Nomad SERVICE BULLETIN

NOSE WHEEL UNDERCARRIAGE — EXCLUSION OF NOSE WHEEL SHIMMY CONTRIBUTORY FACTORS

NMD-32-9

Figure 1

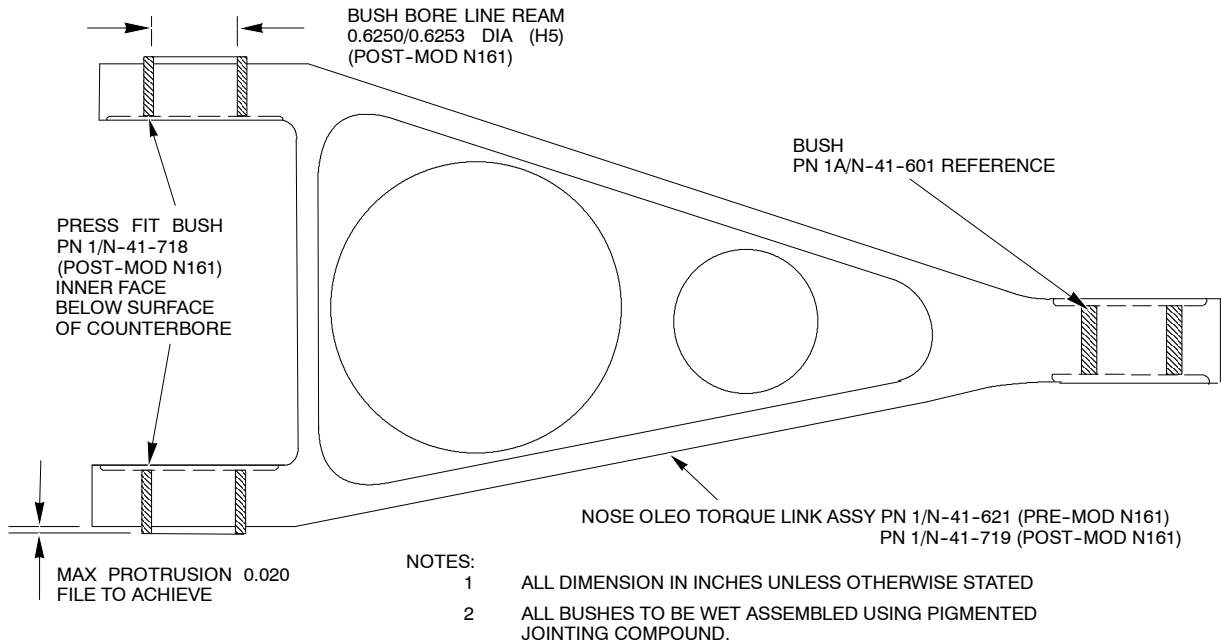
- (3) Remove bushes PN 1/N-41-681 (4 off) from links assy PN 1/N-41-621 and replace with new bushes PN 1/N-41-718. Push fit bushes ensuring that inner face of bush remains below the counter bored surface. Maximum bush protrusion on outside face of links to be 0.020 in. Bush may be filed to achieve this dimension. Line ream bushes to 0.6250/0.6253 in dia and clean out swarf (Ref Fig 1).

Figure 2

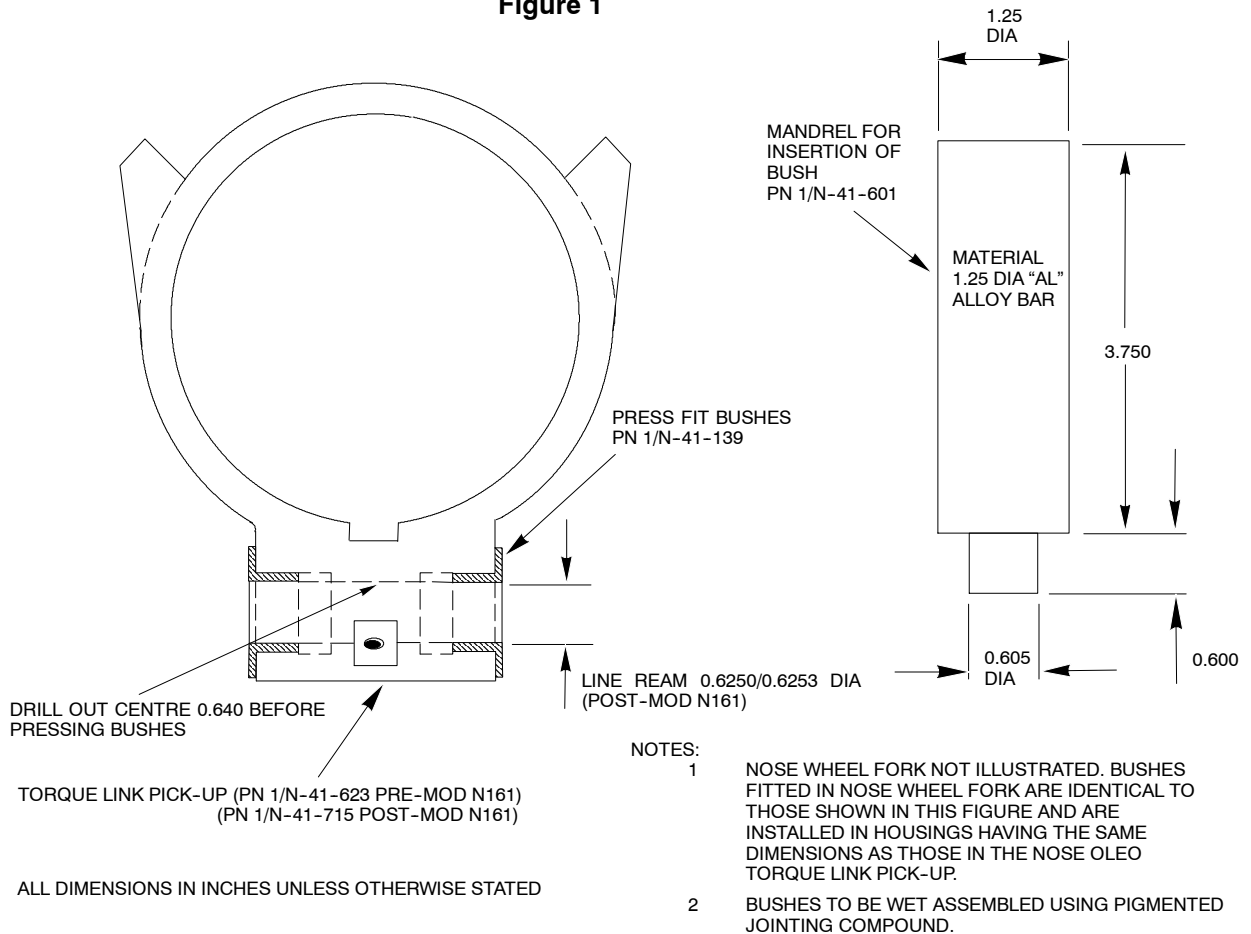
- (4) Using a copper drift remove and inspect bushes PN 1/N-41-139 from nose wheel fork PN 1/N-41-657 (Ref IPC Chap 32-20-03). Drill out centre of nose wheel fork pivot pin hole to 0.640 in dia to provide clearance within hole for line reaming new bushes. Refit serviceable bushes PN 1/N-41-139 using locally manufactured mandrel. Line ream bushes to 0.6250/0.6253 in dia and clean out swarf. Repeat for bushes PN 1/N-41-139 within torque link pick-up PN 1/N-41-623 (Ref IPC Chap 32-20-03 & Fig 2).

Figure 3 Puller for Nose Oleo Torque Link Bushes

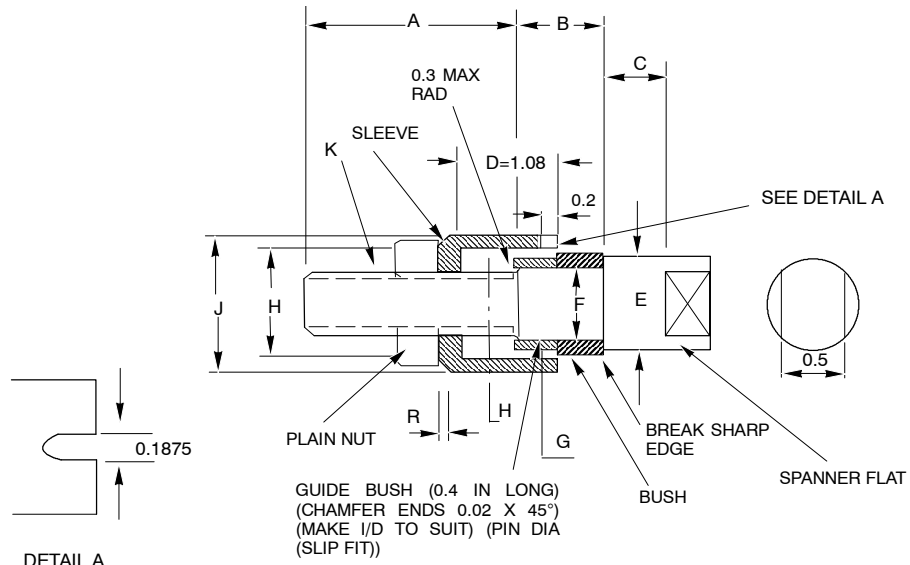
Use locally manufactured puller for removal and insertion of bushes to prevent damage to bushes and links (Ref Fig 3).

Figure 4 Post Mod N161 Torque Links Assy 1/N-41-719 (Assy Components)

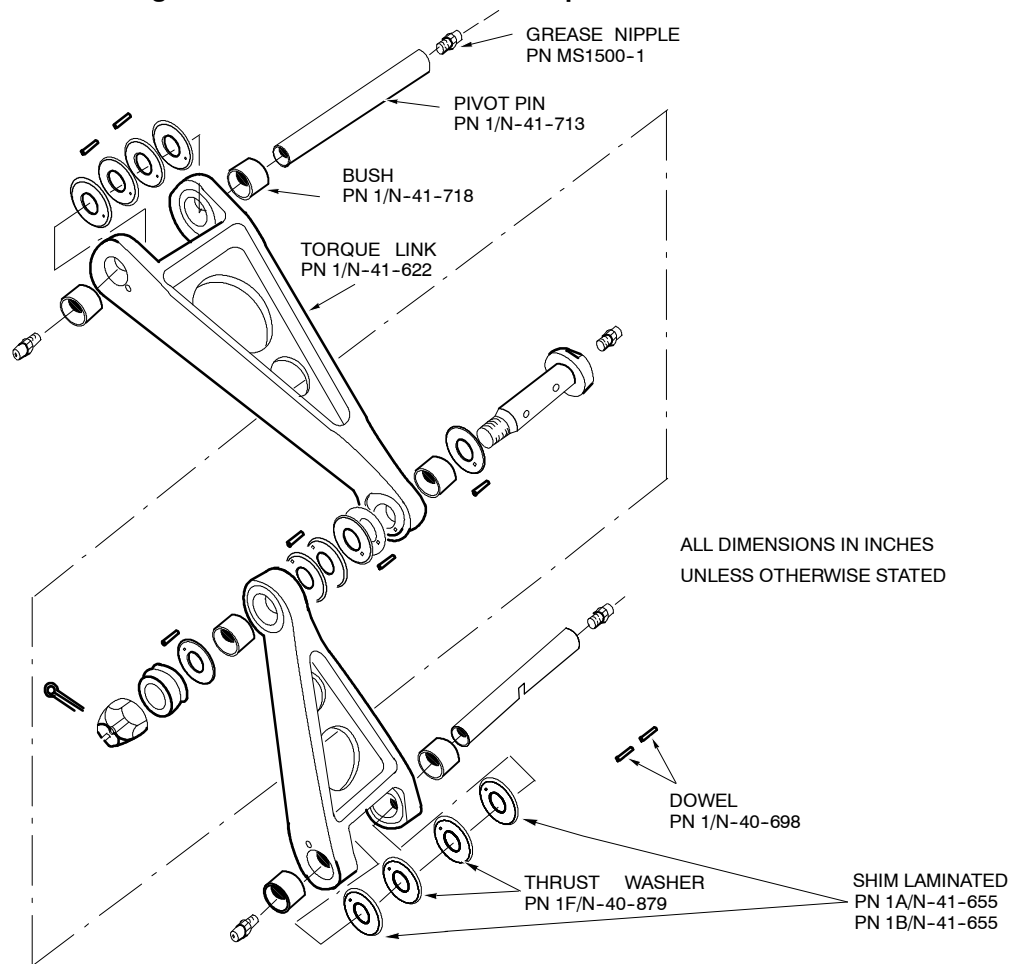
- (b) Using feeler gauges measure free play gap between thrust washer and torque link pick-up.
- (c) Select from laminated shim PN 1A/N-41-655 (0.002 lamination) and PN 1B/N-41-655 (0.003 lamination) which will, when fitted, reduce free play gap to 0.001 in maximum. This will allow assembly such that the shims fitted either side of torque link pick-up have a maximum differential of 0.002 in.

- (d) Repeat steps (a) to (c) for lower torque link connection to nose wheel fork.
- (e) Assemble the torque links assy, to upper and lower attachment points on the leg using lubricated pivot pins PN 1/N-41-713 complete with lubrication fittings PN MS 15001-1 (removed in Part 1 Para 2 above).
